NORME
INTERNATIONALE
INTERNATIONAL
STANDARD

60821

AMENDEMENT 1
AMENDMENT 1

**VMEbus –
Microprocessor system bus
for 1 byte to 4 byte data**

Figure 4-8 – Release of the interrupt request lines by ROAK and RORA INTERRUPTERS

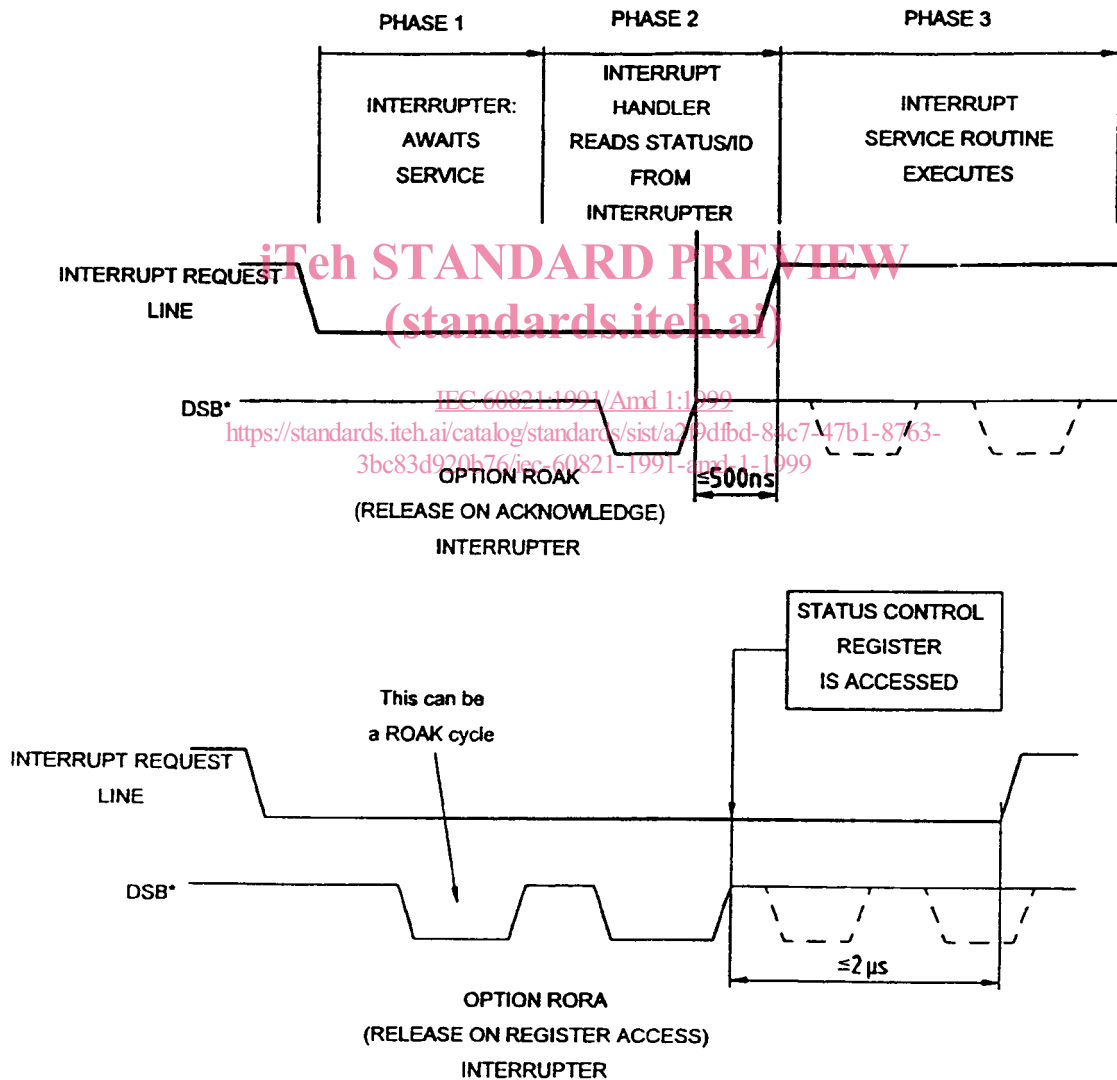
Figure 4-8

Replace figure 4-8 by the following new figure:

Figure D-5 – VMEbus arbitration structure; dashed circles indicate where critical input conditions can arise
 a) simplified block diagram;
 b) control signals, with evidence of the handshake loop (MASTER - REQUESTER - ARBITER - REQUESTER - MASTER)

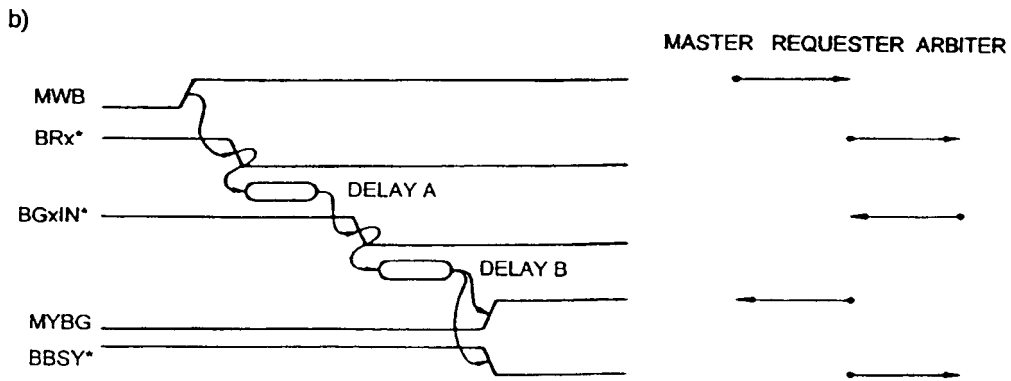
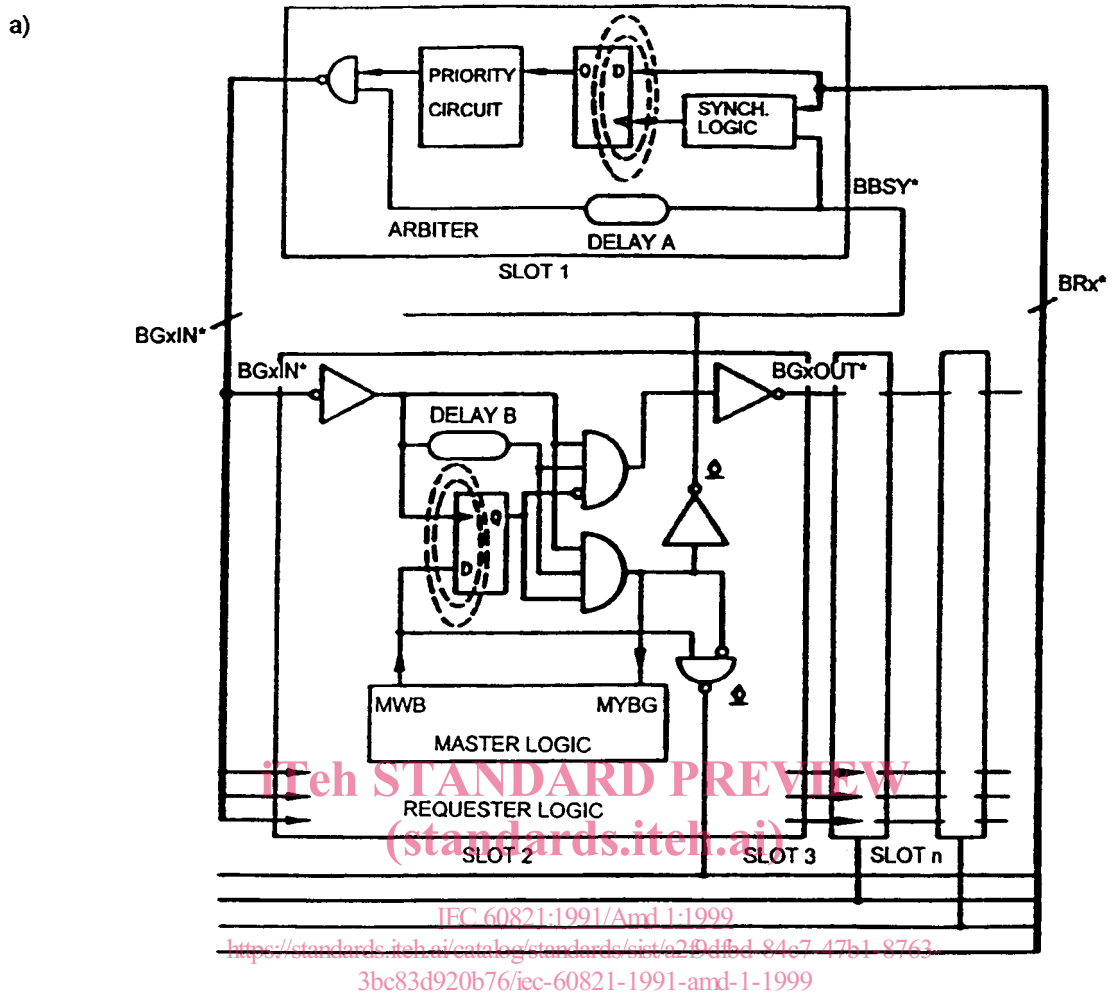
Replace, on page 527, figure D-5 by the following new figure:
